**LITTLE SHENANGO DAM**

**PHASE I INSPECTION REPORT**  
**NATIONAL DAM INSPECTION PROGRAM**

LITTLE SHENANGO DAM (PA 490)  
MERCER COUNTY, COMMONWEALTH OF PENNSYLVANIA  
NDI NO. PA 00246  
PennDER NO. 43-54

Little Shenango Dam (PA 490), Mercer County, Pennsylvania  
NDI No. PA 00246, PennDER No. 43-54  
Calvin Clark Run  
Inspected 6 December 1978

LITTLE SHENANGO DAM  
 NDI NO. PA-00246  
 PLAN SKETCH  
 Approx. Scale 1" = 100'  
 12-6-78  
 12-13-78  
 JVH

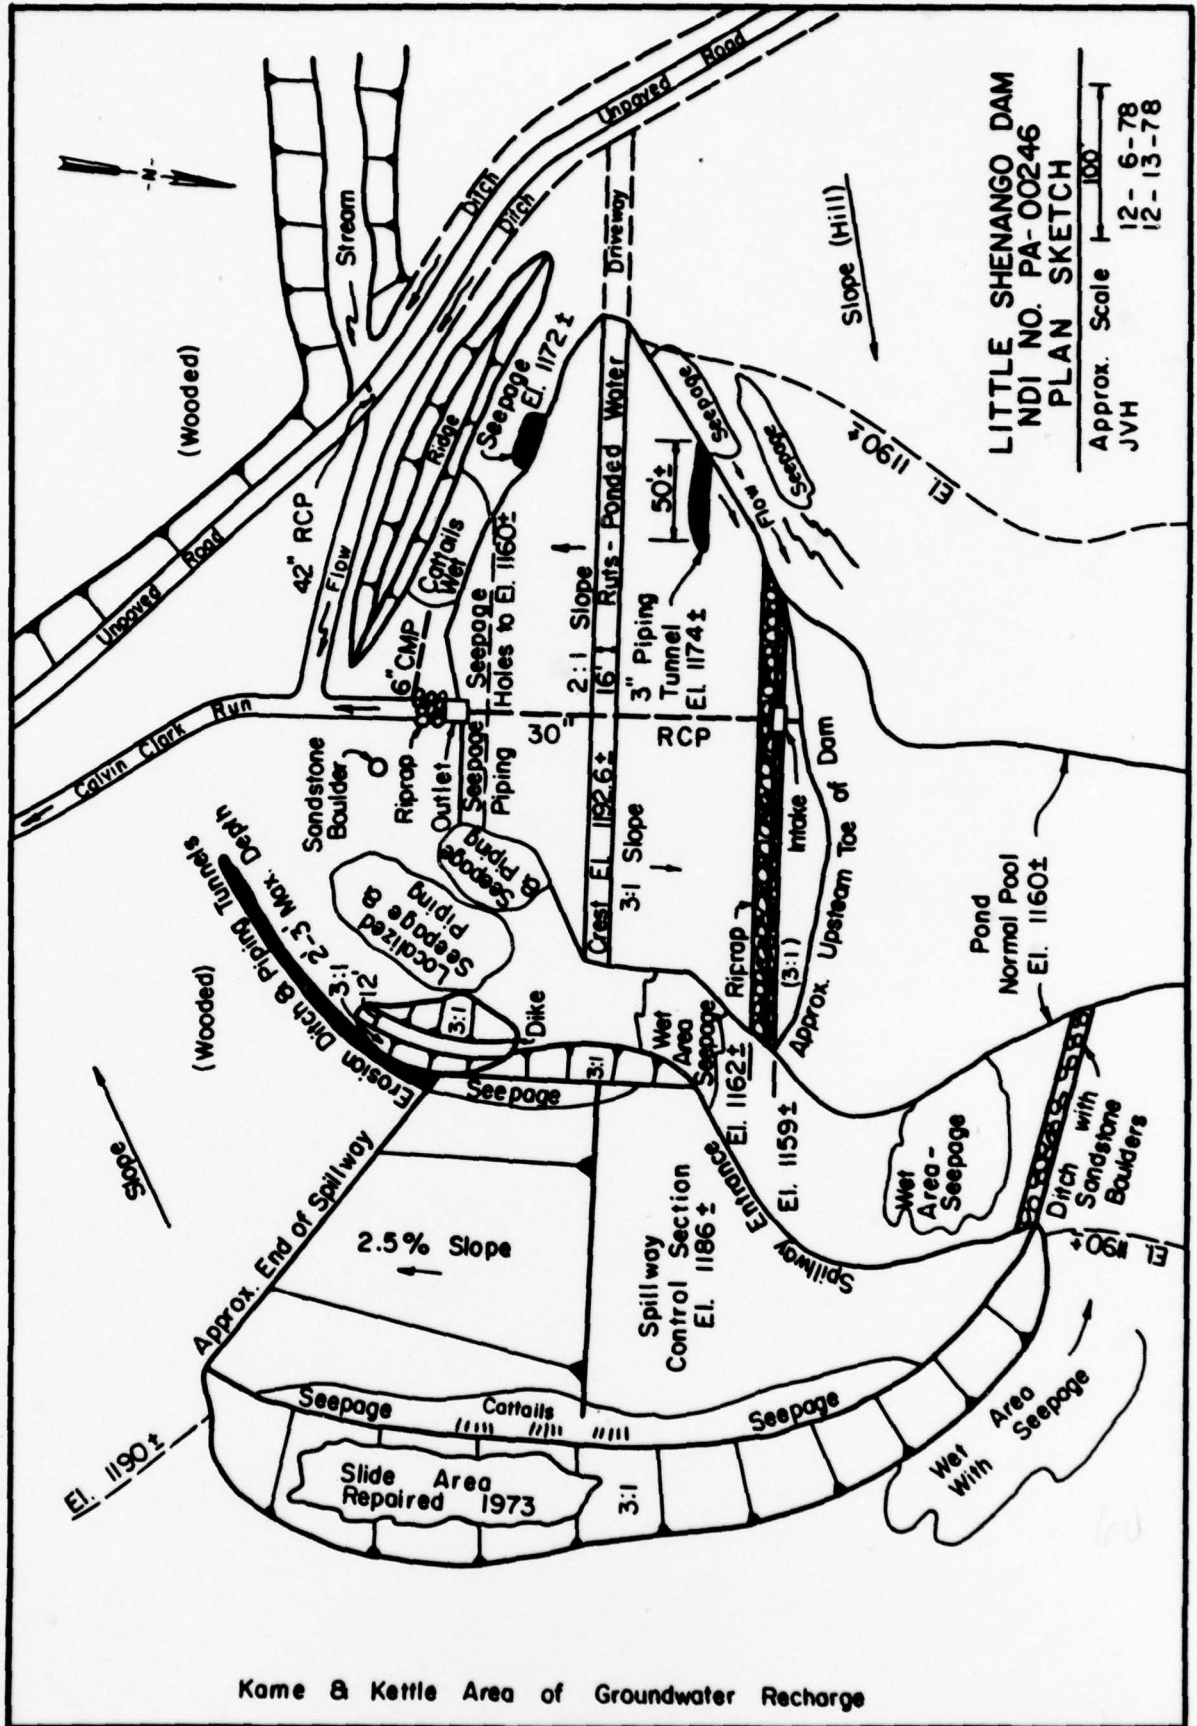
- b. Dam - Seepage and evidence of piping (internal erosion of fine soil particles) was observed at several locations in the dam embankment and its abutments. These seepage and piping areas are shown in the field sketch (Appendix A), and they are described briefly below and in detail in the Seepage and Piping Supplement.

A 3-inch diameter piping tunnel was noted at a depth of about 1 foot in silty fill on the right (west) side of the upstream slope of the dam at El. 1174+ feet. This tunnel appeared to extend horizontally some 50 feet left from the right abutment contact before turning into the embankment in an area where the fill is denser and well graded. It seems likely that this tunnel was produced by piping due to flow from springs in the right abutment as normal pool level is El. 1160 feet.

Surface water flow along the downstream right (west) side of the spillway, perhaps in combination with flow from springs in the left (east) abutment area, has produced a line of erosion gullies and piping tunnels with maximum depths of 2 to 3 feet from the downstream right side of the spillway toward the stream (El. 1180-1170+ feet). These features are in silt of glacial ice contact

- c. Appurtenant Structures - Minor to moderate seepage was observed at several locations along the toes of the excavated slopes on both sides of the spillway (field sketch), and piping features were observed in the silt along the downstream right (west) side of the spillway as noted in paragraph 3.1.b. All of these seepage and piping areas are well above normal pool level. They are attributed to natural groundwater flow from the left (east) abutment area and they are not considered detrimental to stability or operation of the spillway.

It is recommended that a more detailed investigation of abutment, embankment, and foundation seepage and piping conditions be made as expeditiously as possible. In this investigation, particular attention should be directed to determination of (1) nature and extent of glacial soil deposits at the dam site, (2) local patterns of natural groundwater flow, (3) locations and extents of silt and fine sand zones in the dam embankment and abutments, (4) locations and extents of piping (internal erosion) conduits in the dam embankment and abutments, (5) seepage patterns in the dam embankment, and (6) condition and efficacy of granular drains in the dam foundation and abutments.
